SAFETY EVALUATION REPORT BY THE OFFICE OF NUCLEAR REACTOR REGULATION

SUPPORTING AMENDMENT NO. 75 TO OPERATING LICENSE NPF-1

TROJAN NUCLEAR PLANT

DOCKET NUMBER 50-344

Figure 1 - Modified Fuel Assembly Location

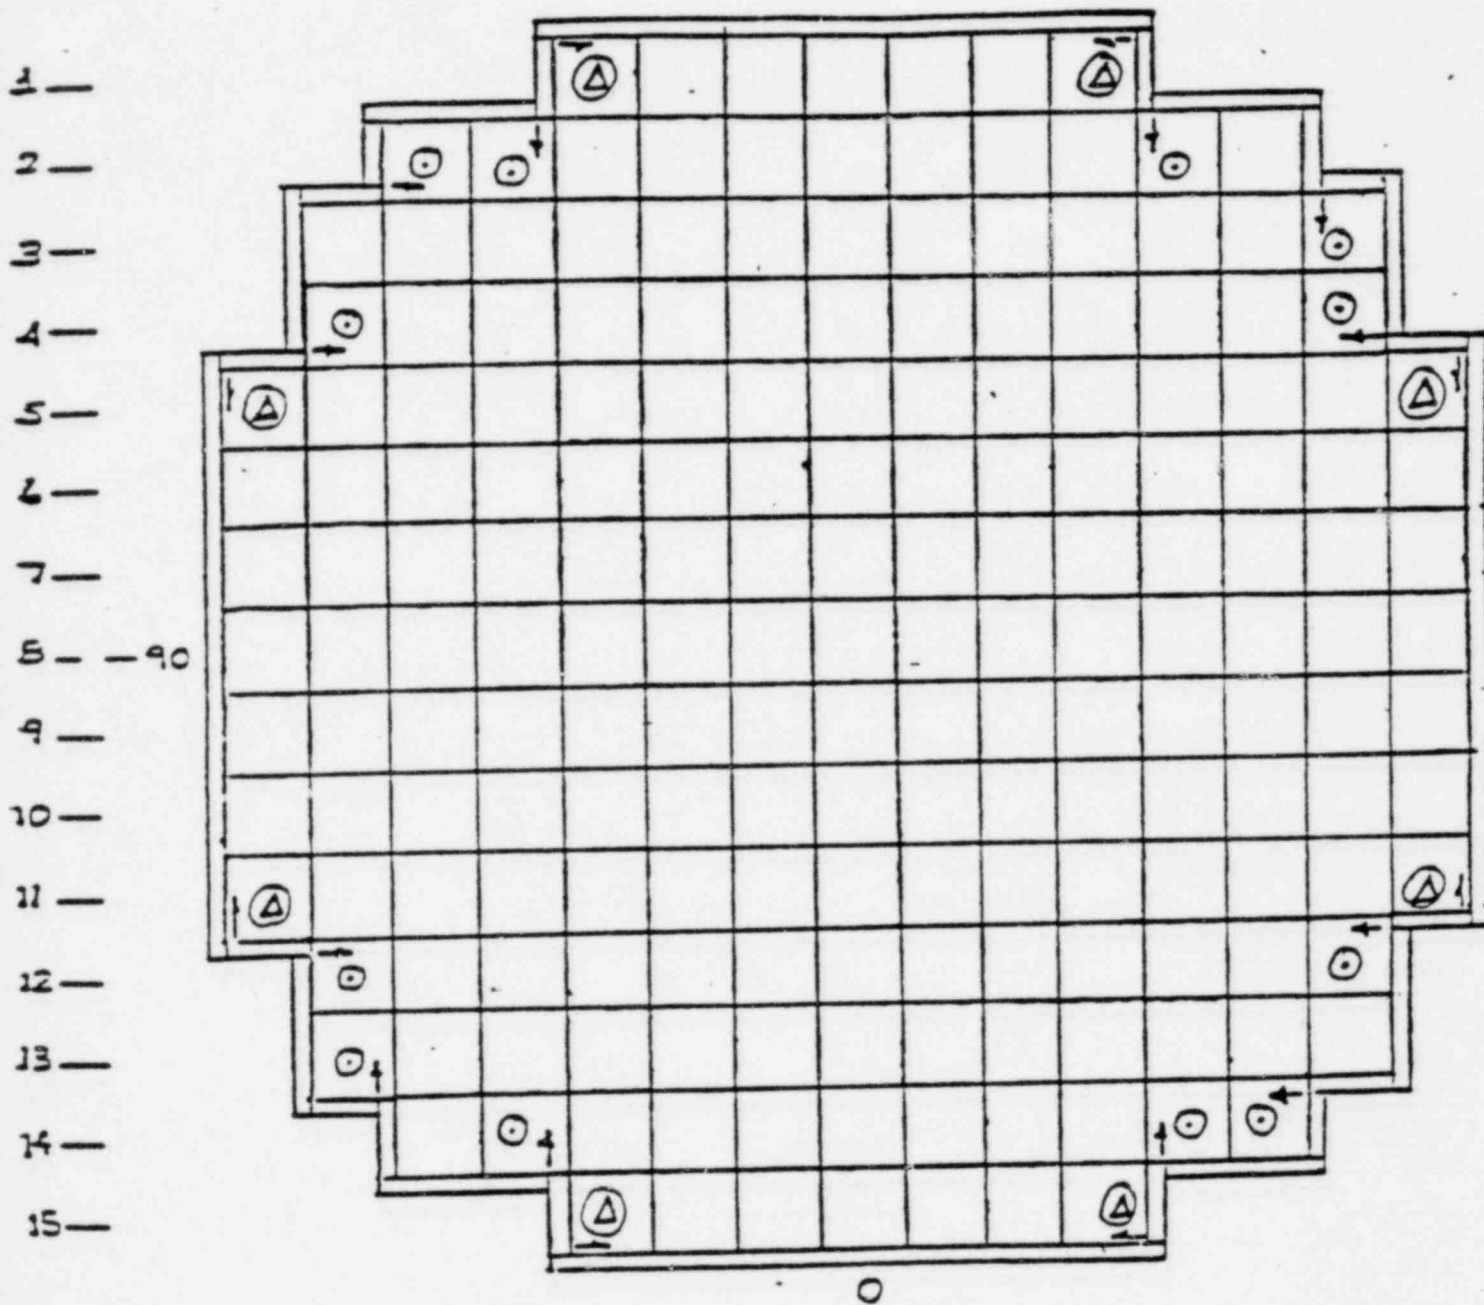
In Cycle 5 twenty modified 17x17 fuel assemblies containing dummy stainless steel rods to replace fuel rods are to be placed on the outer periphery of the core (see Figure 1). Our evaluation is to find the effect of these modified fuel assemblies on the thermal-hydraulic performance. Eight of the assemblies which are in the corner-injection locations also have a further change in that they have partial "mini" grids to encompass a 2x8 array of rods to provide additional support for the five stainless steel rods and three adjacent fuel rods in Row 1 of the modified fuel assemblies, plus the eight fuel rods in Row 2 behind the stainless rods. For each of these fuel assemblies a total of seven partial grids are to be inserted midspan between the full grid assembly to help reduce the vibration of the rods located in the 2x8 partial grids.

We find that the modifications to the fuel assemblies are acceptable since the changes are small and the new modified fuel assemblies are in the low power peripheral core locations where their effect on the thermal-hydraulic performance is minimal. This conclusion is based on the modified fuel assemblies being in their outer periphery locations in the core. Further use of modified fuel assemblies will require NRC review and approval.
